Planning & Zoning Commission Meeting

Monday, May 2, 2022 at 5:00 P.M.

PLANNING AND ZONING COMMISSION
Staff Report: Site Development Plan

**RE: Parking Demand Analysis: Proposed Private School Development
The KnILE Center Private School; 902 Richmond Parkway, Richmond Texas**

**SITE PAVING &
GRADING PLAN**

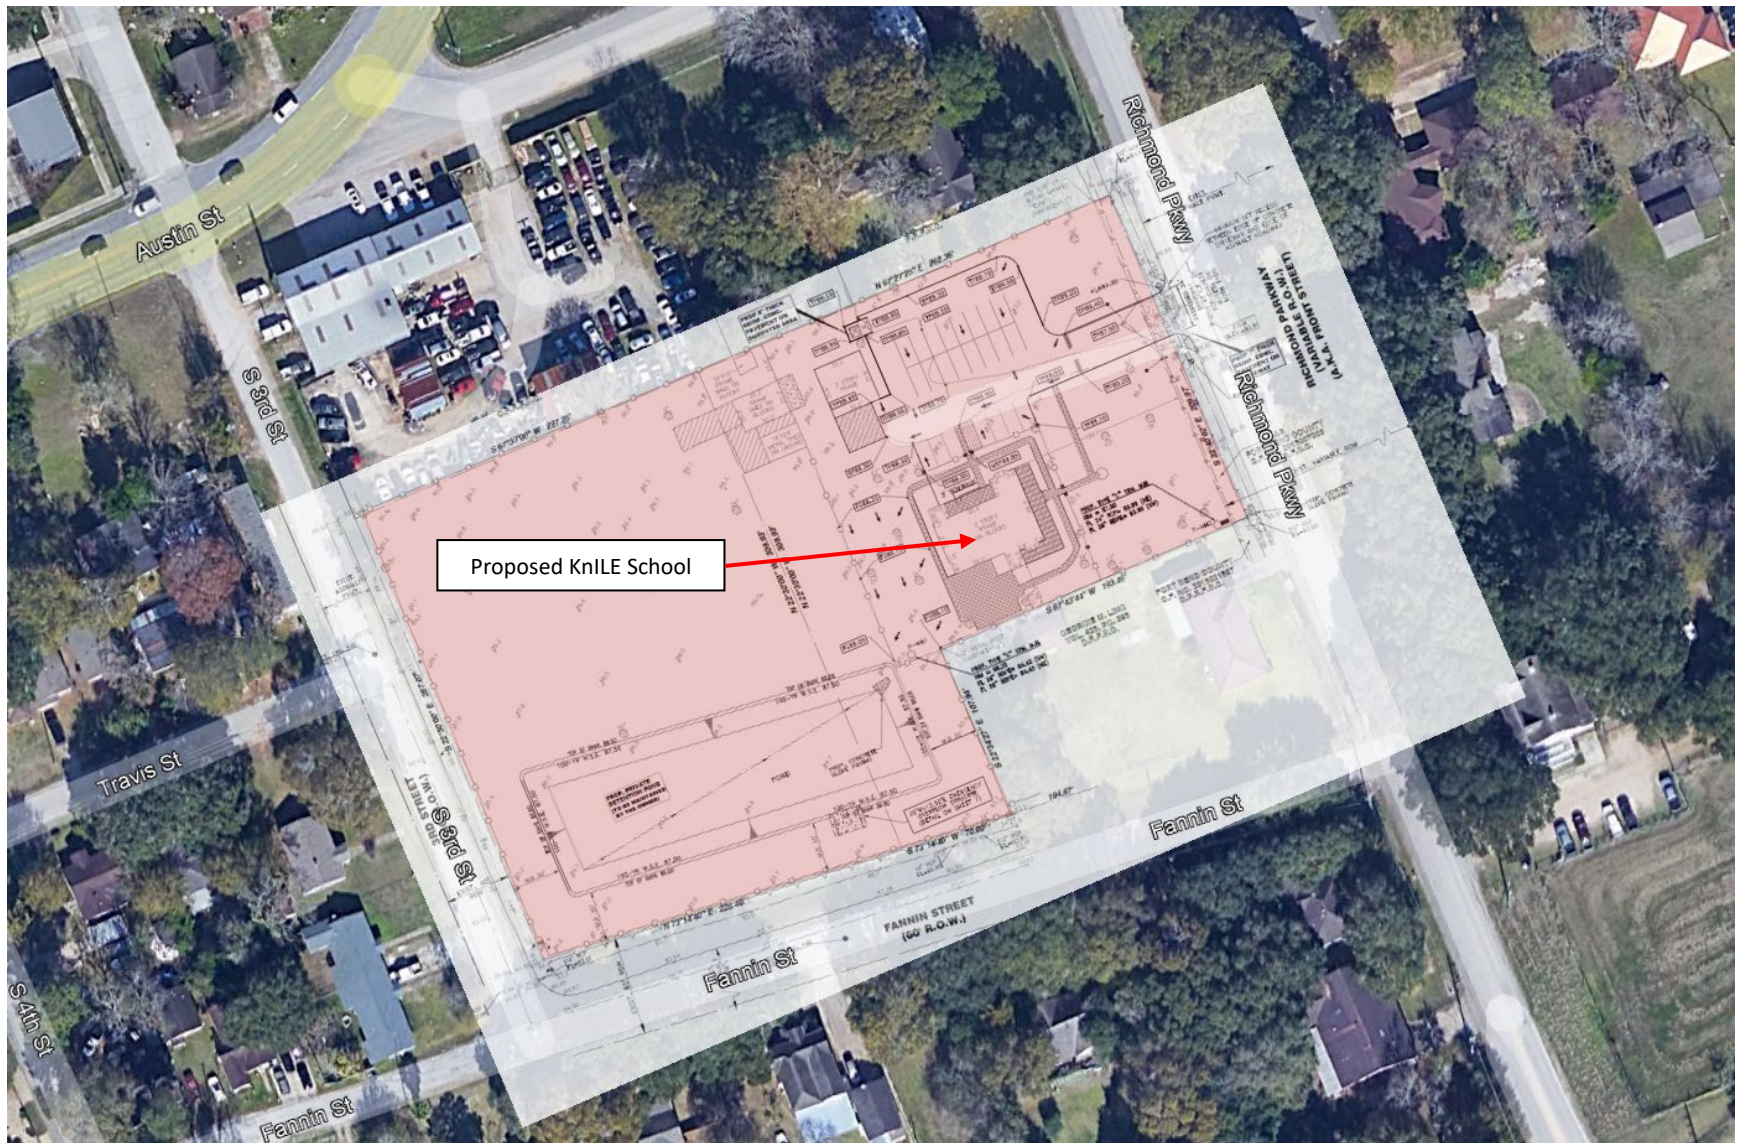
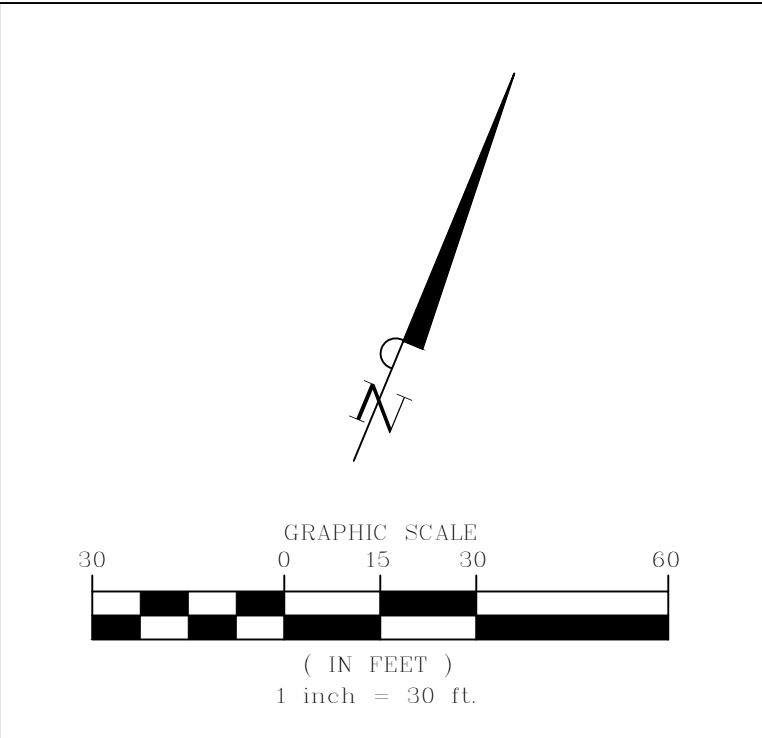
- The provided study (attached) does not include a peak parking analysis for five comparable use as required by Section 4.2.103.B. The study uses parking demand based on Institute of Transportation Engineers (ITE) Manual for Elementary and K-12 School. However, please note that the ITE manual for elementary schools use data from 5 different schools.

- The parking study uses average and 85th percentile peak demand data for Elementary schools as well as Private K-12 schools. The Elementary school data is based on one study site. Private K-12 data is based on school with significantly large enrollment, which would represent larger student population that drive to school.

- The study does not provide a peak parking demand for the existing Knile Center location.
- Please note the following information from the study (for 75 student):

- Please note that this study is solely for establishing a parking requirement for the site. It does not include space for queueing for parent drop-off or pick-up operations. The details pertaining to queueing will be made part of a separate Traffic Impact Analysis which will be provided as a separately.

Based on the submitted parking study, staff recommends approval of the following parking requirements for the proposed school located at 902 Richmond Parkway:

- 0.30 Vehicles per student / 23 parking spaces
